Subject: Modification to S8PSBS05W

This letter is to formally notify you that the following modification has been completed by Compatible Electronics, Inc. to our Base Station, S8PSBS05W during FCC certification, and will be implemented in production.

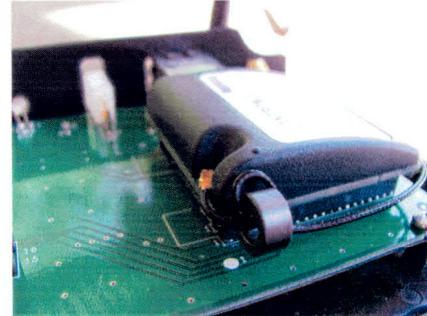
Modification: A torroid ferrite (Fair-Rite P/N: 2643002402) was installed on the coaxial cable going from the Lantronics, 802.11 module to the antenna. It has 1 1/2 turns so that the ferrite is stable and not moving. See picture at right.
